Georgetown
University
Hospital

Reference: License #08-30577-01 License Amendment
Supplemental Information for Request Dated 26-July-2011

Re: Request for Additional Information – Reference Control 575679

**FINAL STATUS SURVEY
WORK PLAN ~ Former Radioactive Waste
Storage Facility**

Attachment 1

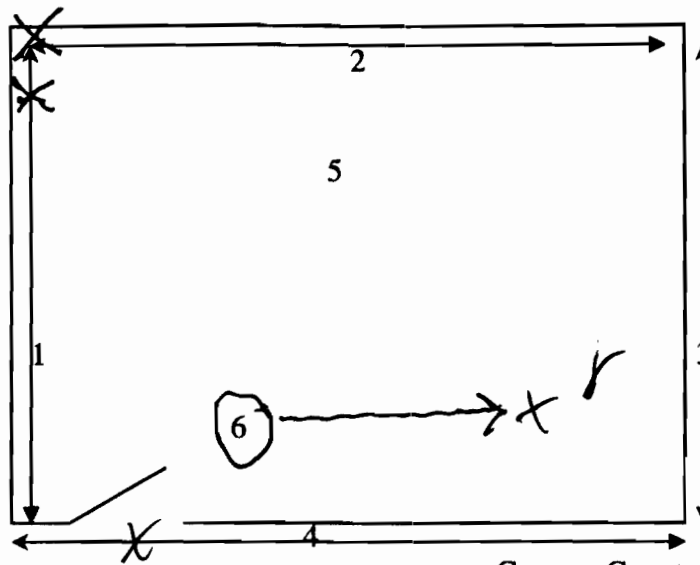
What activities have been completed to attempt decontamination of the area exhibiting radioactive contamination listed in Table 4 or the "Final Status Survey Report" dated July 19, 2011 to demonstrate ALARA?

Weekly area surveys were being performed for the concrete building up to the week of June 20, 2011 to ensure acceptable radiation levels within the structure as well as the absence of contamination from stored radioactive material. An example of a weekly area survey for the week of June 20, 2011 is shown in attachment 1.
